SUBJECT : Contract PSC-302 with RCA for UMR-1 Radio Sets
(P-79C)

REFERENCE : Memo for Record dtd 8 February 1957 Subj: RCA
UMR-1 Radio Transmitter-Receiver, P-79C

RCA UMTR-1 MODIFIED FOR CONCEALMENT
Microphone-headphone terminals and switching details.

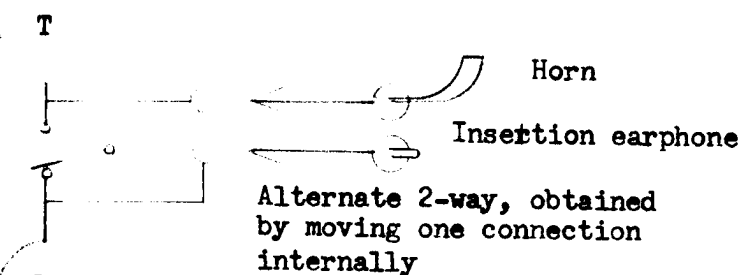
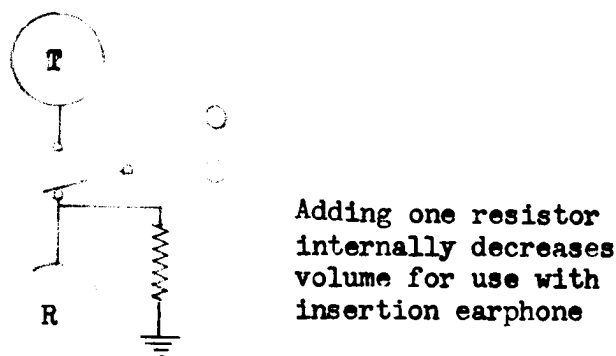
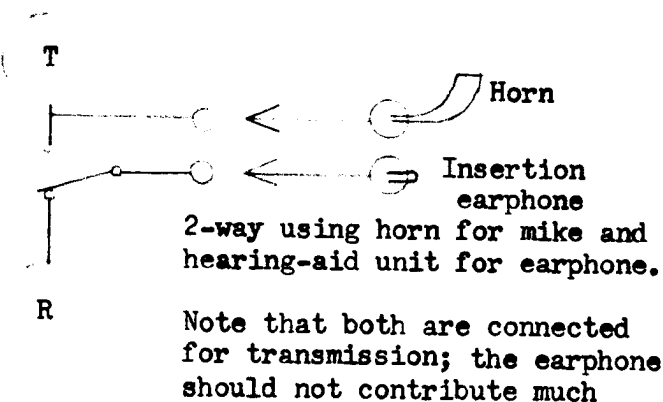
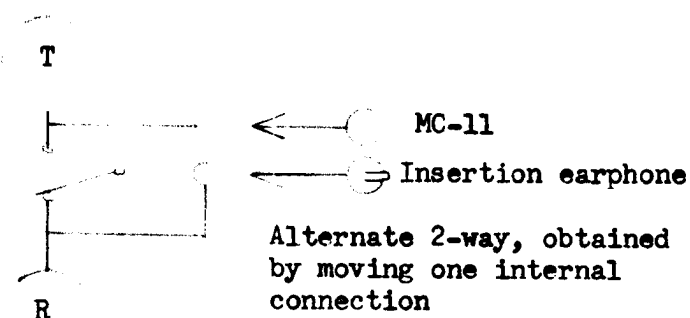
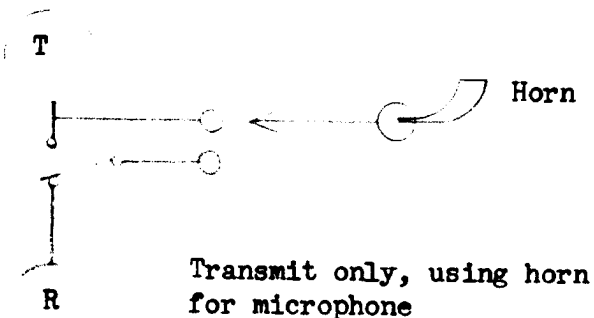
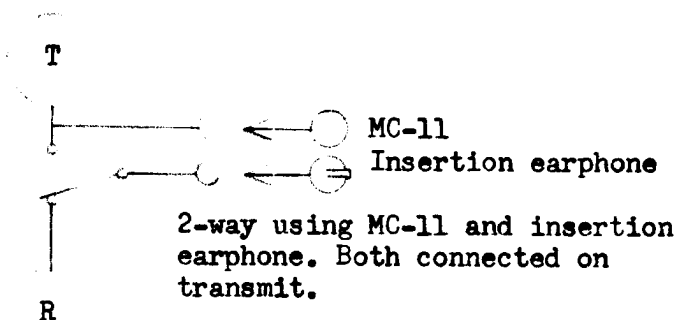
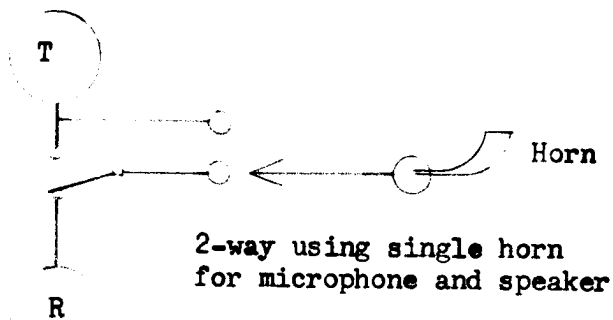
d. From the electrical standpoint it would be feasible to provide a third jack connected to the fixed "receive" switch terminal, and such an arrangement would provide the maximum flexibility in choice of transducers. However, adding this jack would involve reworking a fairly critical part of the equipment, would delay delivery, and might increase the cost.

e. With the present circuit an insertion earphone connected to the switched jack will act as a microphone on transmission, but the level of pickup is too low for adequate modulation. If a microphone is simultaneously connected to the transmit jack the microphone output will override the output of the earphone on transmission.

f. If the output from the earphone on transmission is considered objectionable, it can be eliminated by moving one soldered connection on the switch.

g. As mentioned in the reference, a resistor may be added internally (at the switch terminals) in order to decrease the receiving volume to a level suitable for use with an insertion earphone.

4. In view of the above, and in the interest of early delivery, it seemed desirable to leave the circuit as is. Instructions will be furnished for changing the switch connections and adding the resistor where necessary. The various operating arrangements which may be used are shown schematically on the attached sheet.
